Item Name: AS350/AS355 Heli-Utility-Basket™ Long Version Split Lid - Fits LH or RH

DART SERVICE INSTRUCTION

**TO AMEND INSTALLATION INSTRUCTIONS D350-607-1 REV. A AND
INSTRUCTIONS FOR CONTINUED AIRWORTHINESS ICA-D350-607 REV. 6**
REF CANADIAN STC: SH94-14
REF FAA STC: SR00213NY
REF EASA STC: 10016996

A	NEW ISSUE	MB	14.09.25
REV.	DESCRIPTION	BY	DATE
DESIGN		DART AEROSPACE LTD	
DRAWN		HAWKESBURY, ONTARIO, CANADA	
CHECKED		DRAWING NO.	REV. A
MFG. APPR.	N/A	DSI 9709	SHEET 1 OF 4
APPROVED		TITLE	SCALE
DE APPR.		PARTS LIST CORRECTION	NTS
DATE	14.09.25	COPYRIGHT © 2014 BY DART AEROSPACE LTD THIS DOCUMENT IS PRIVATE AND CONFIDENTIAL AND IS SUPPLIED ON THE EXPRESS CONDITION THAT IT IS NOT TO BE USED FOR ANY PURPOSE OR COPIED OR COMMUNICATED TO ANY OTHER PERSON WITHOUT WRITTEN PERMISSION FROM DART AEROSPACE LTD.

**FIGURE 1: CHANGES TO FIGURE 2 OF D350-607-1 REV. A
AND FIGURE 25-1 OF ICA-D350-607 REV. 6**

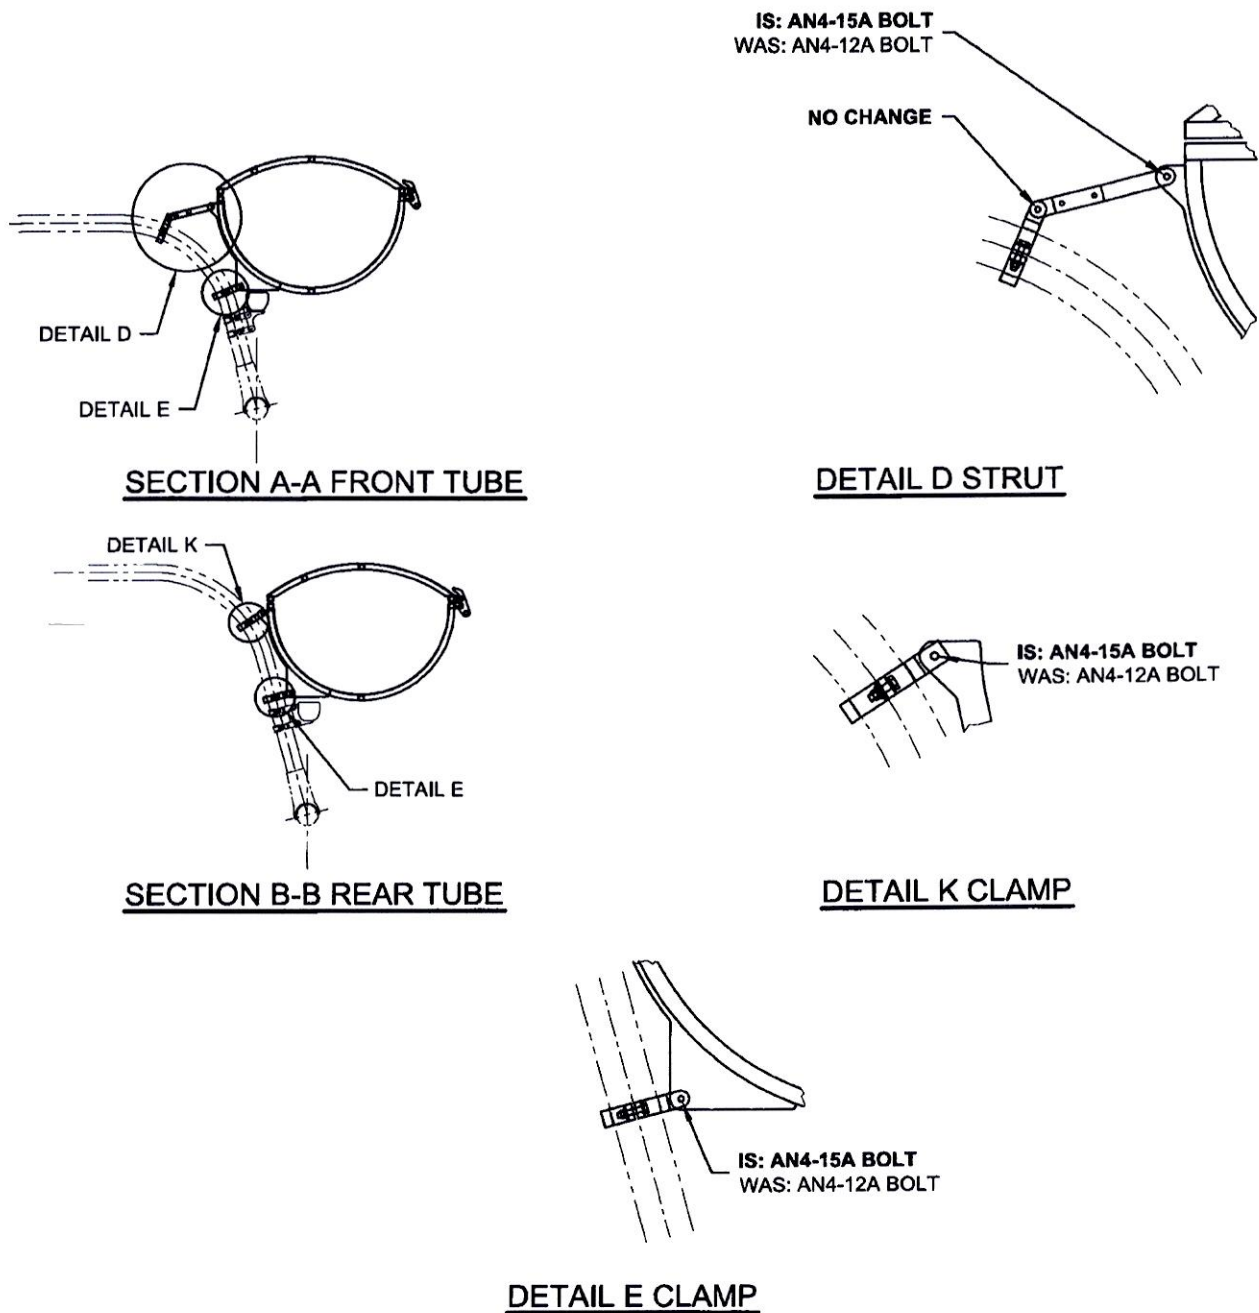
It has come to DART's attention that Installation Instructions D350-607-1 Rev. A and Instructions for Continued Airworthiness ICA-D350-607 Rev.6 were issued with incorrect bolt length information. The purpose of this DART Service Instruction (DSI) is to amend the following items:

- 2.1 Sheet 2 of this DSI amends Figures 2 of D350-607-1 Rev. A and 25-1 of ICA-D350-607 Rev. 6;
- 2.2 Sheet 3 of this DSI amends Figures 3 of D350-607-1 Rev. A and 25-2 of ICA-D350-607 Rev. 6;
- 2.3 Sheet 4 of this DSI amends the Parts Lists of Installation Instructions D350-607-1 Rev. A (Sections 6.1 and 6.2) and ICA-D350-607 Rev. 6 (Sections 25.27.1 and 25.27.2).
